RECEIPT DATE: 9/23/2022 **ONSITE SEWAGE DISPOSAL SYSTEM** P 572133

APPROVAL DATE: 09/23/2022 **PERMIT:** REPAIR A Repair

PROPERTY ADDRESS: 6700 Cortina Drive

Approved Septic System Plan
 Howard County Health Department
 Signature: [Signature]
 Date: 9/23/2022

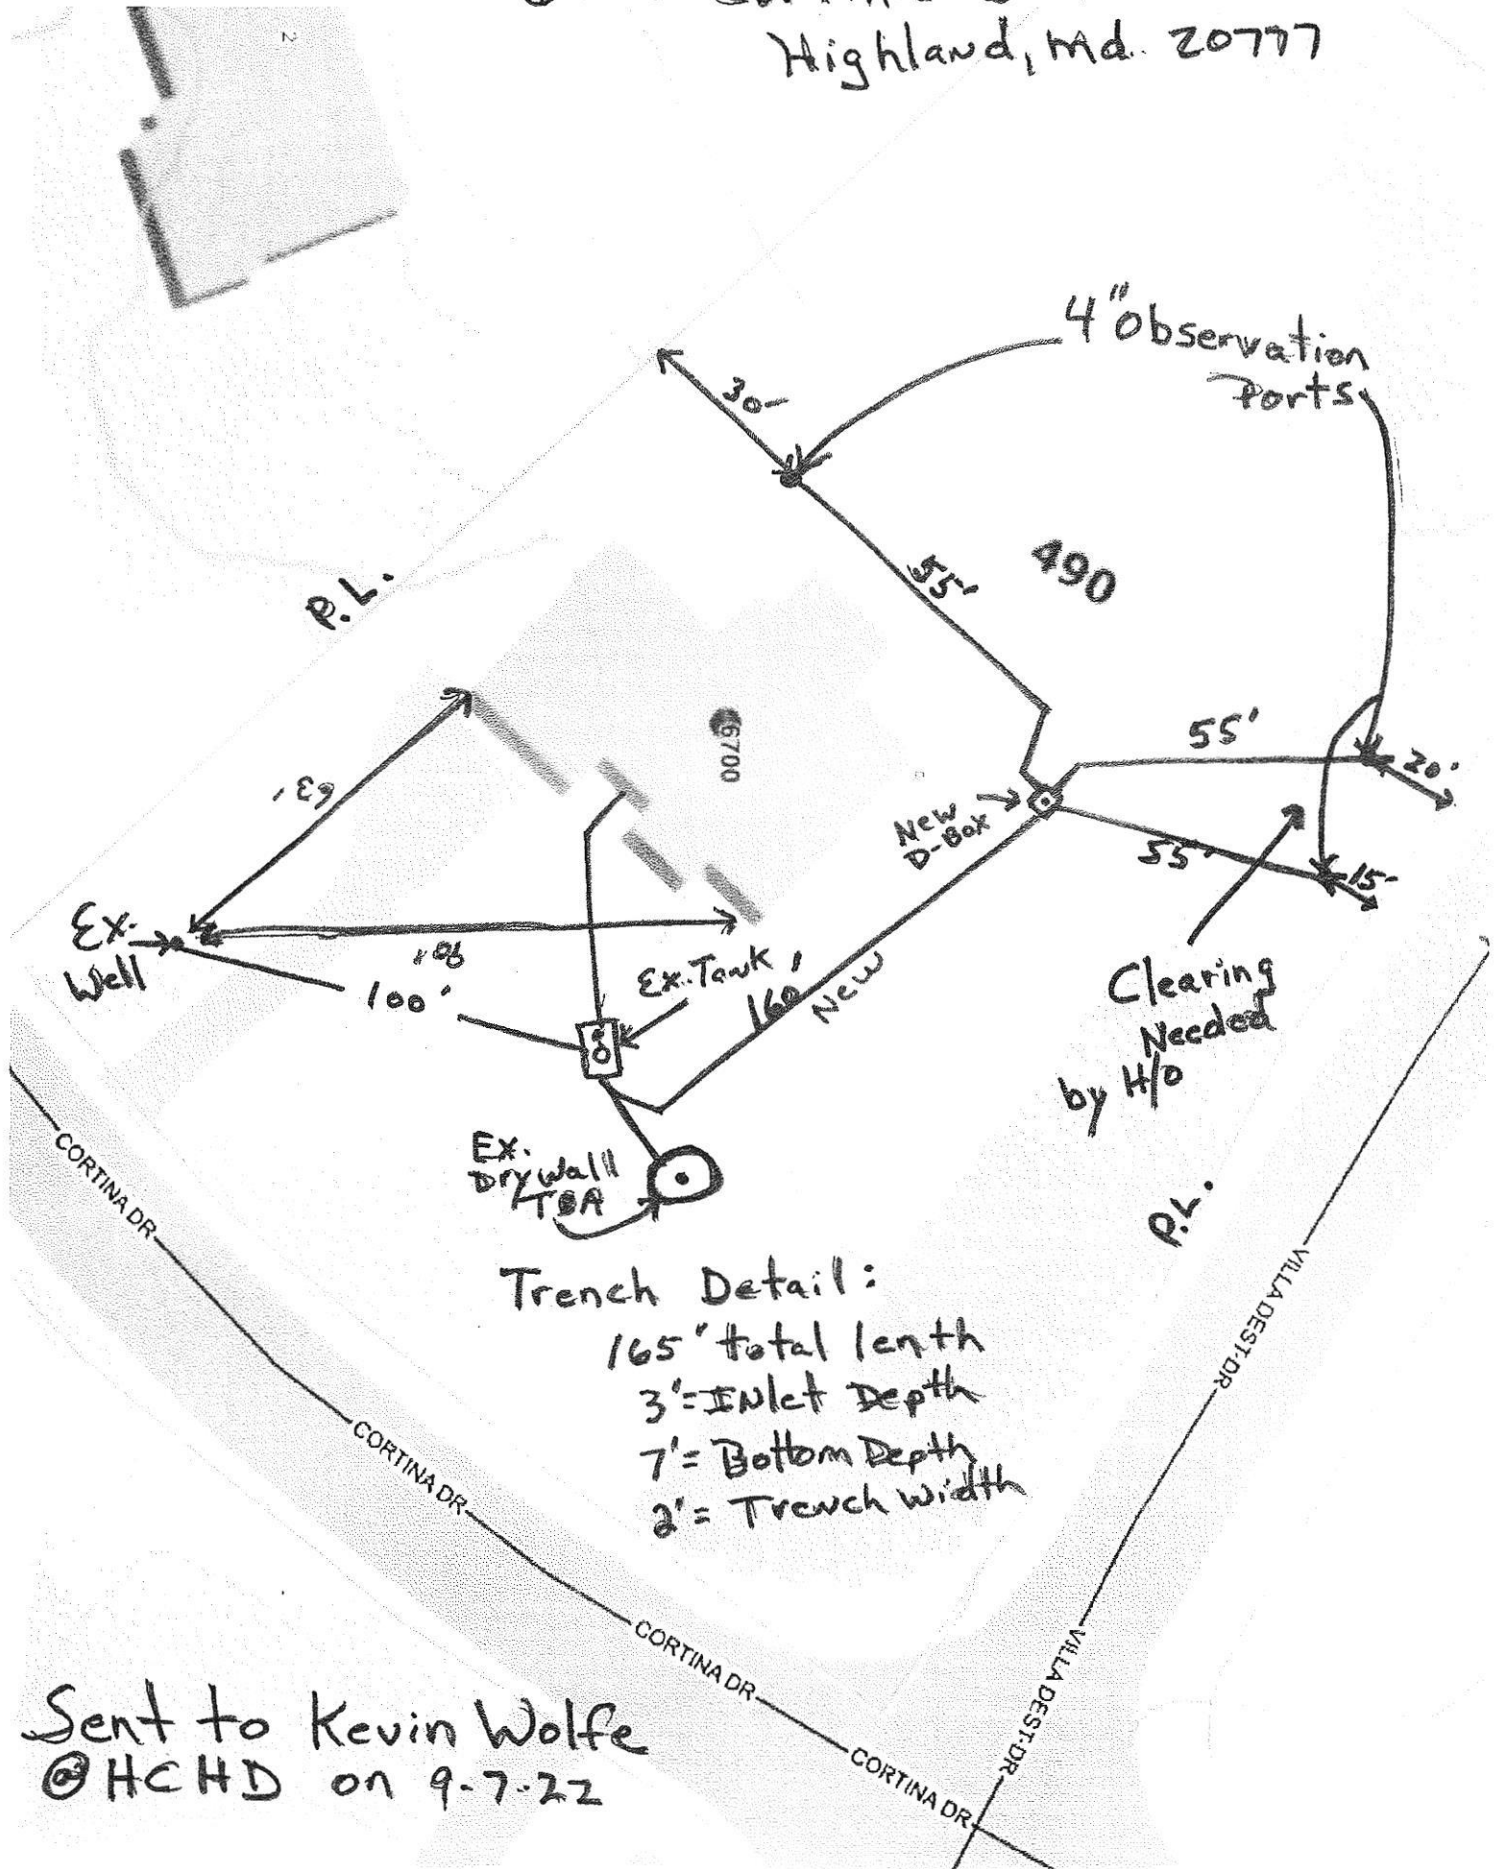
9/23/2022
 Revisions approved.
 Property lines surveyed
 OK to have Dbox approx
 16' to house.
